CITY OF ALBUQUERQUE

Re: Precision Eye Center 7521 Alameda Blvd. NE Traffic Circulation Layout Engineer's Stamp 02-13-23 (C19-D070)

Based upon the information provided in your submittal received 03-16-23, the above referenced plan cannot be approved for Building Permit until the following comments are addressed:

D-101

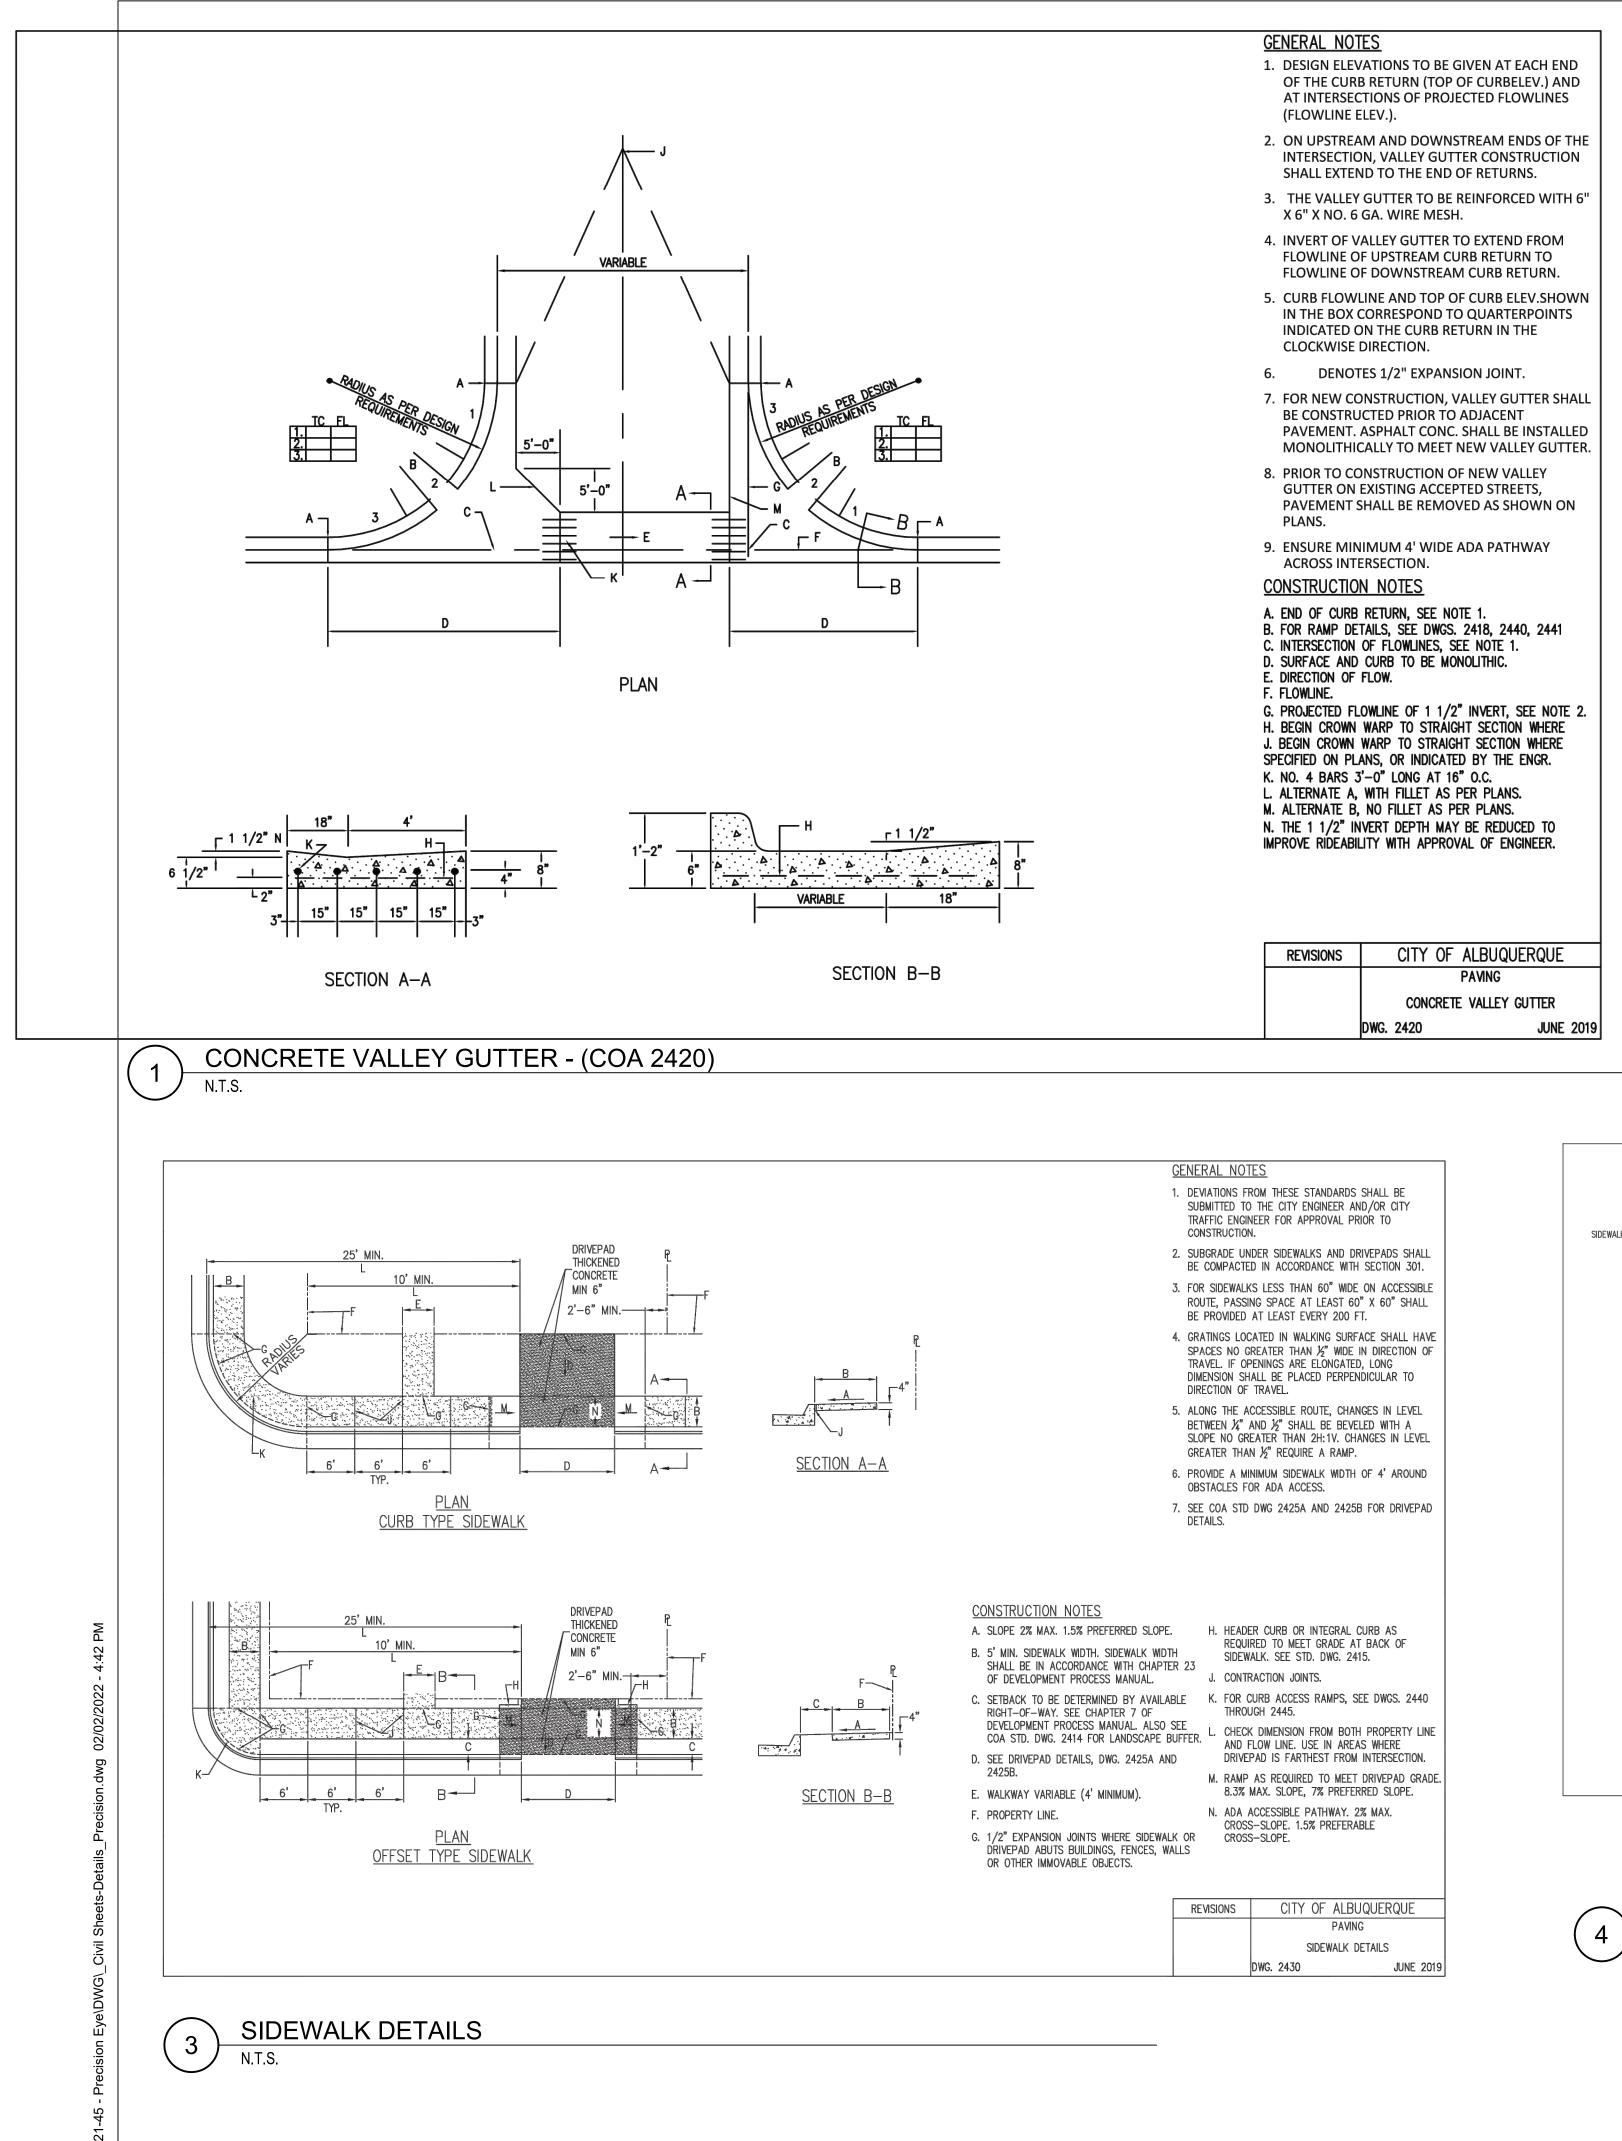
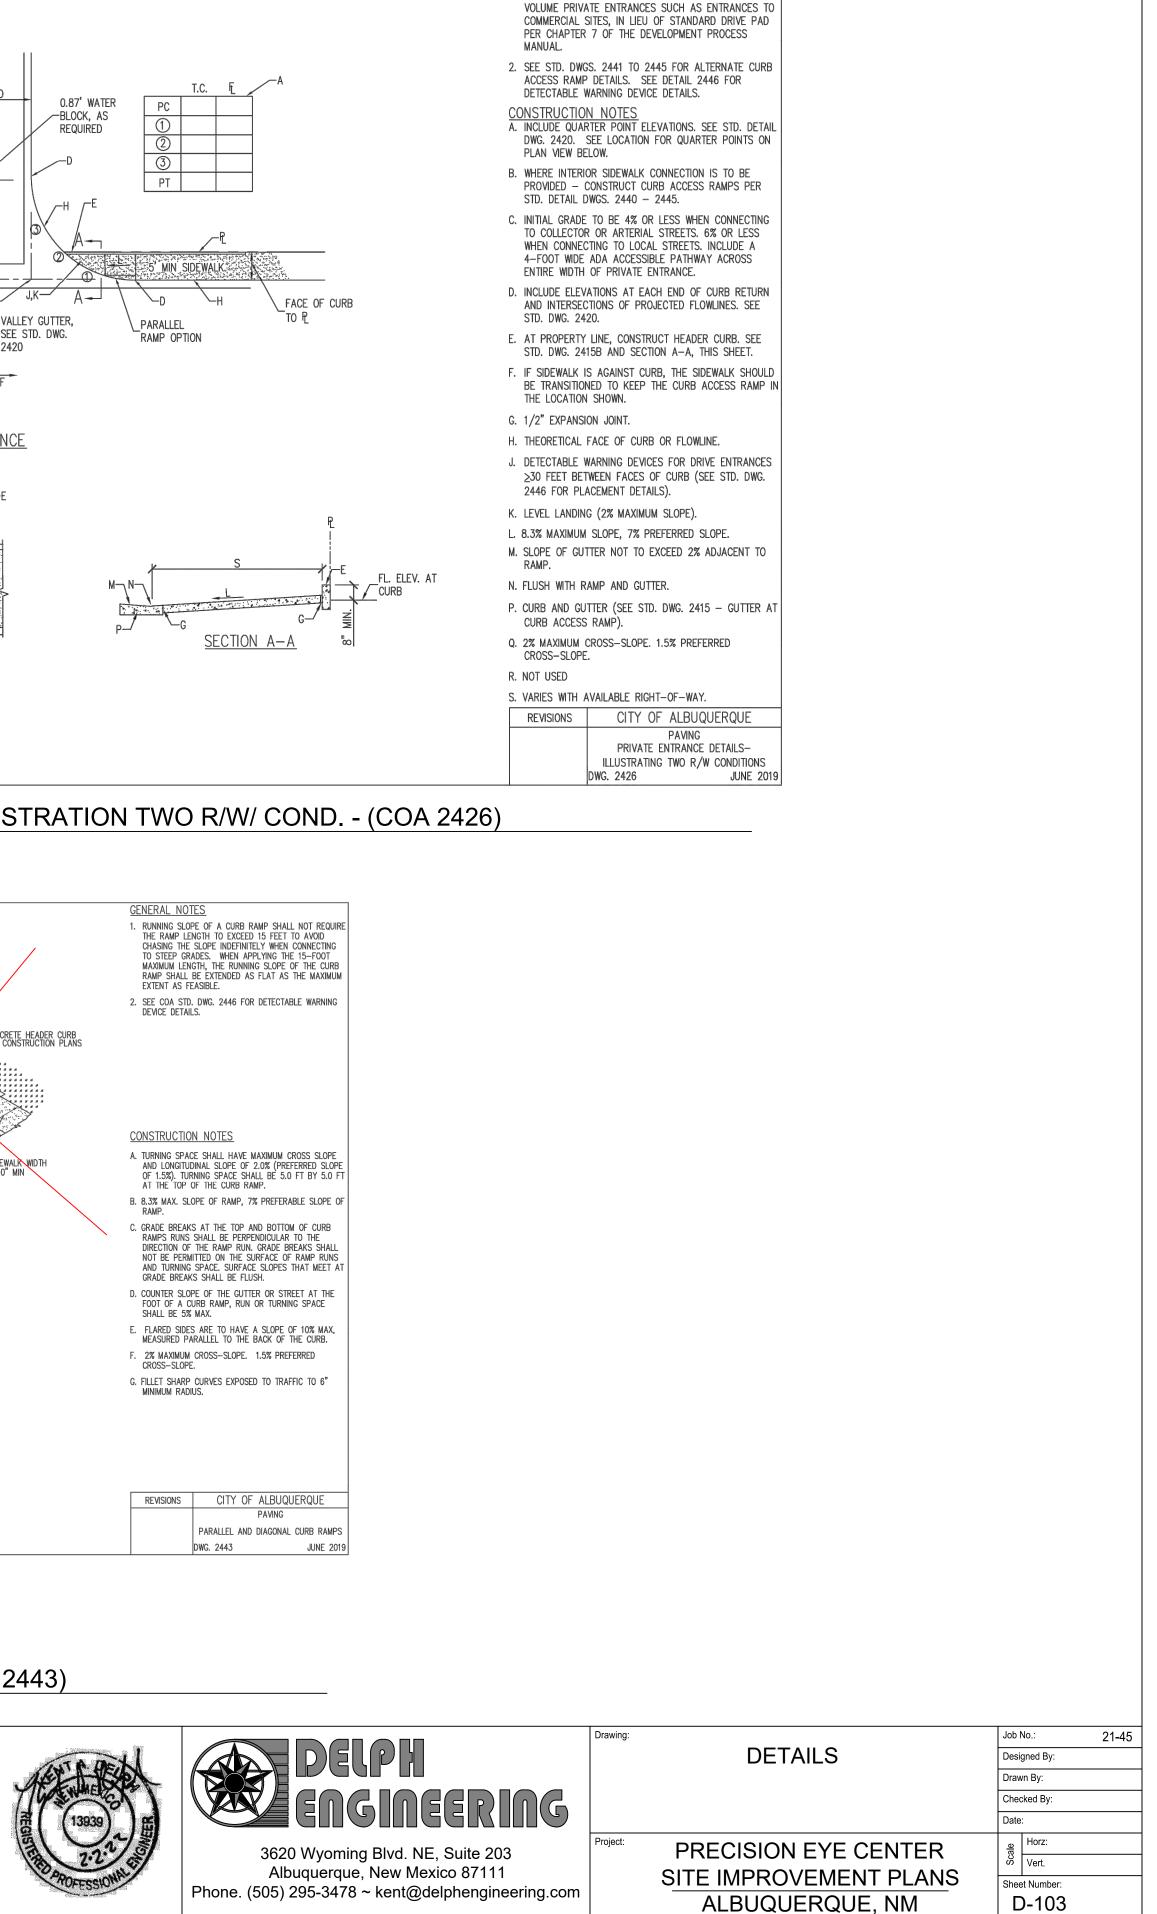
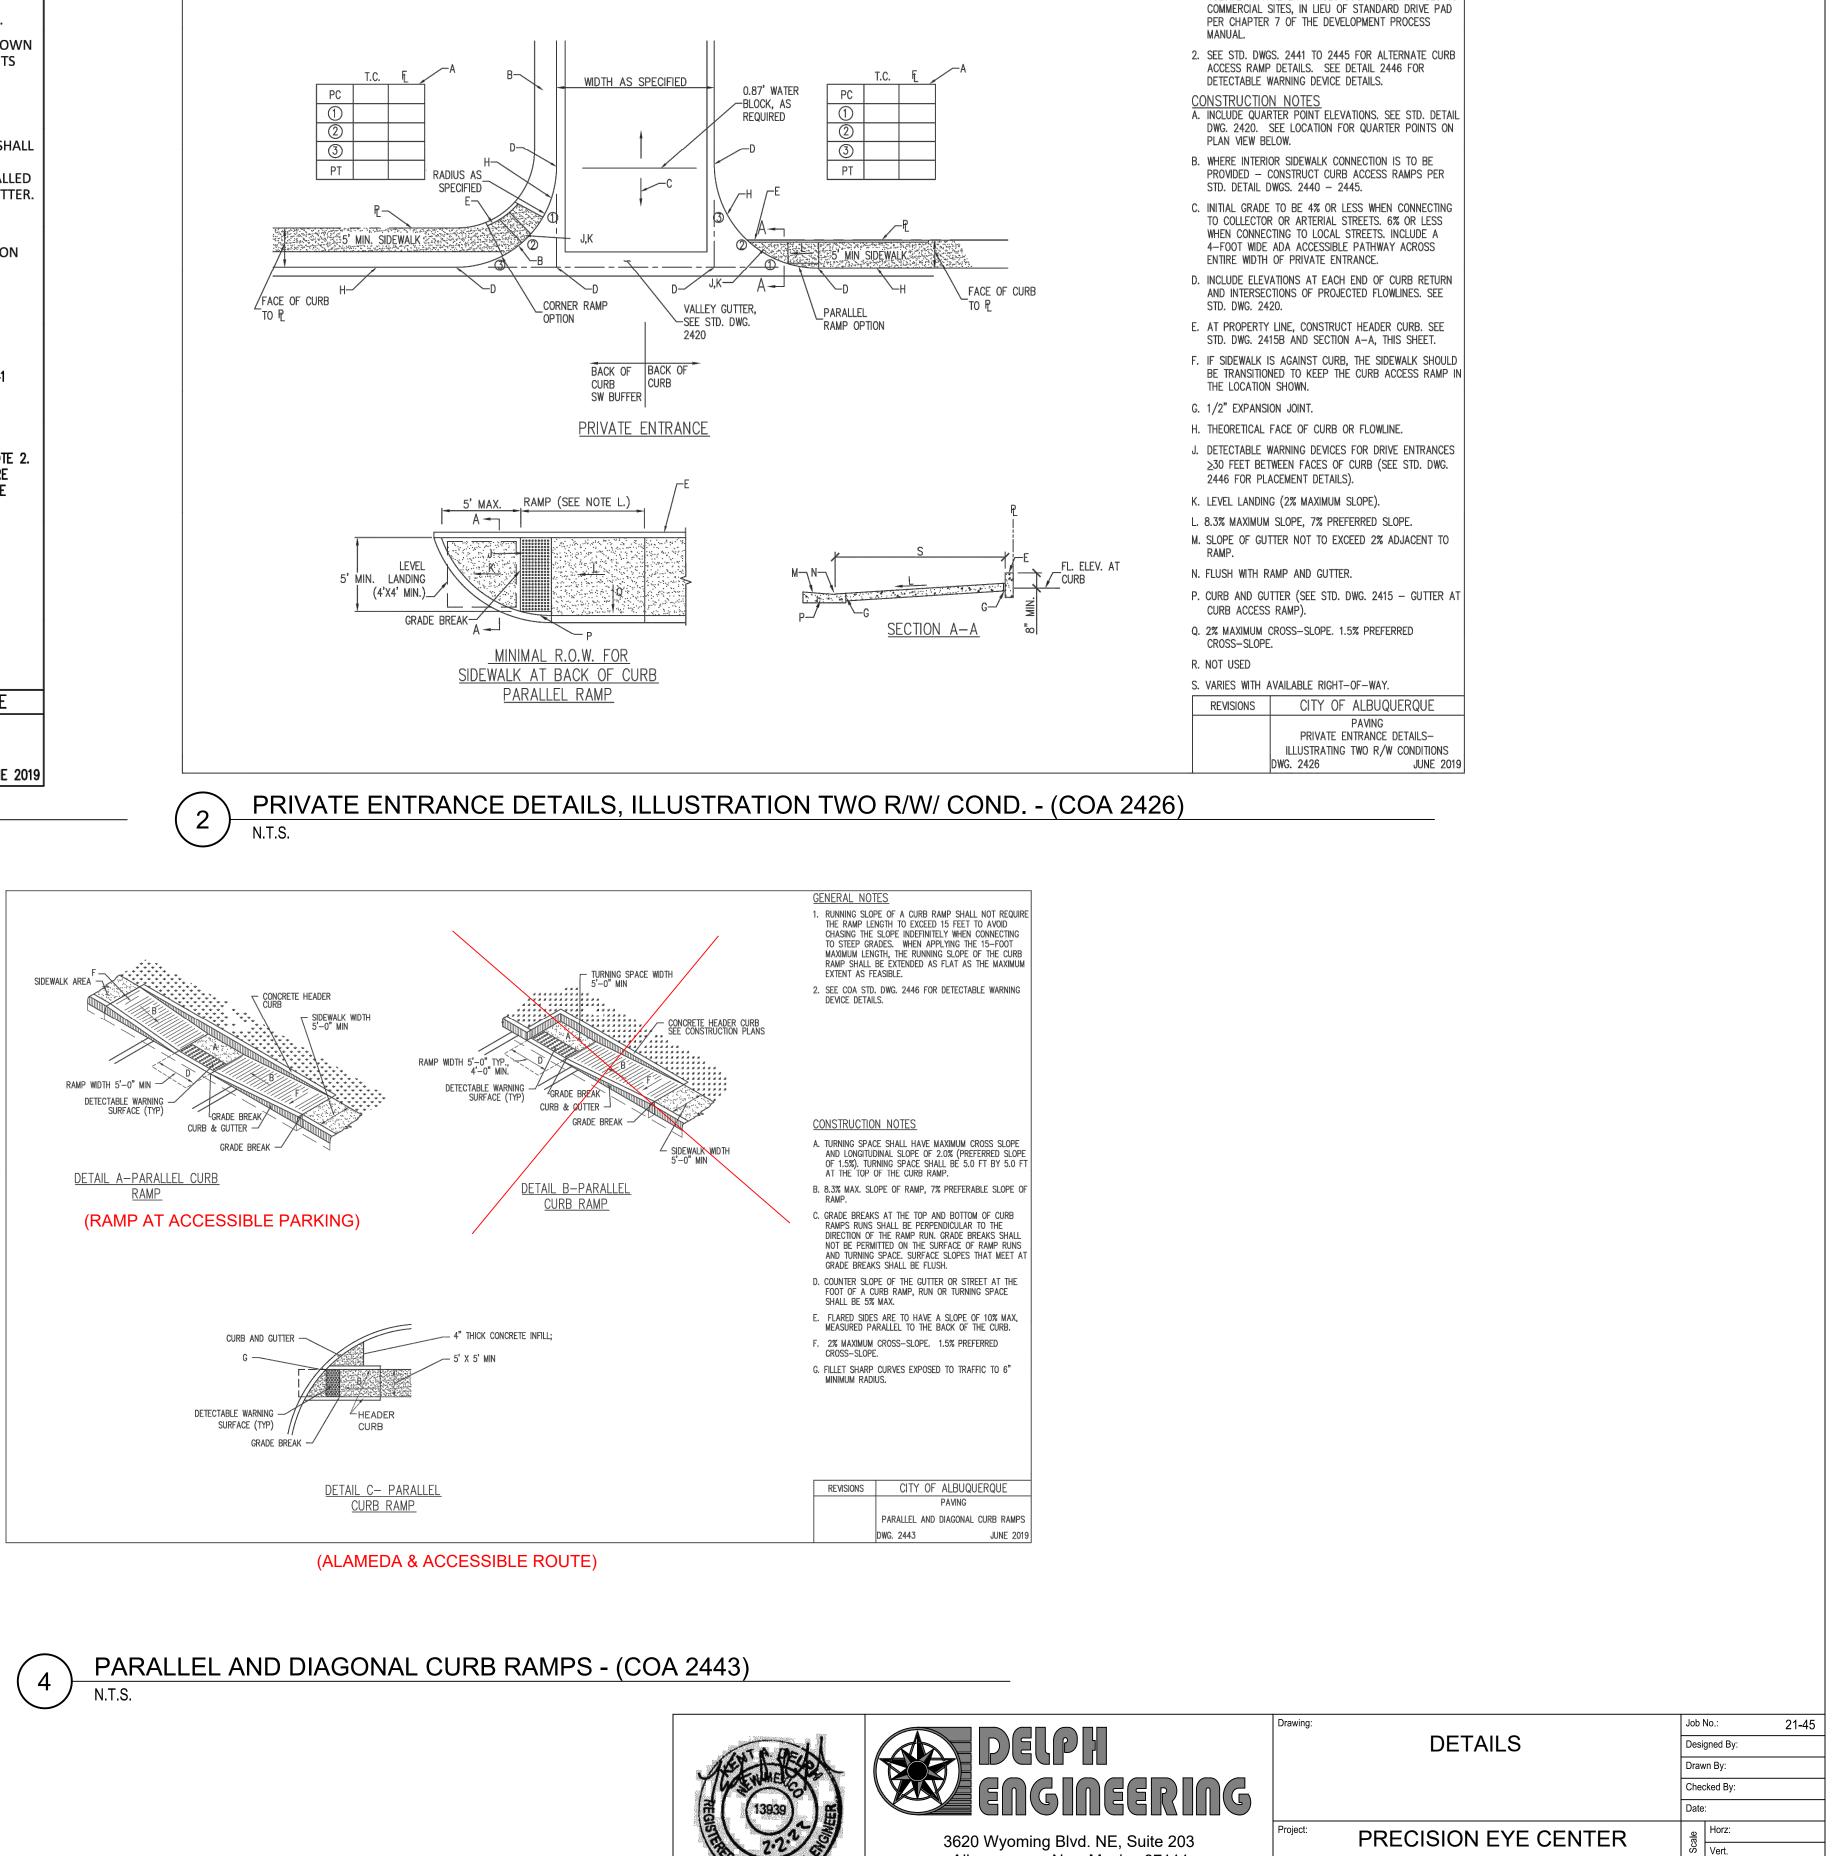
- 4. A 5 ft. keyway is required for dead-end parking aisles.
- 5. Please remove Plumbing details from Transportation details' sheet D-101.
 - 6. Refuse vehicle maneuvering shall be contained on-site. The refuse vehicle shall not back into the public right of way.; provide a copy of refuse approval.
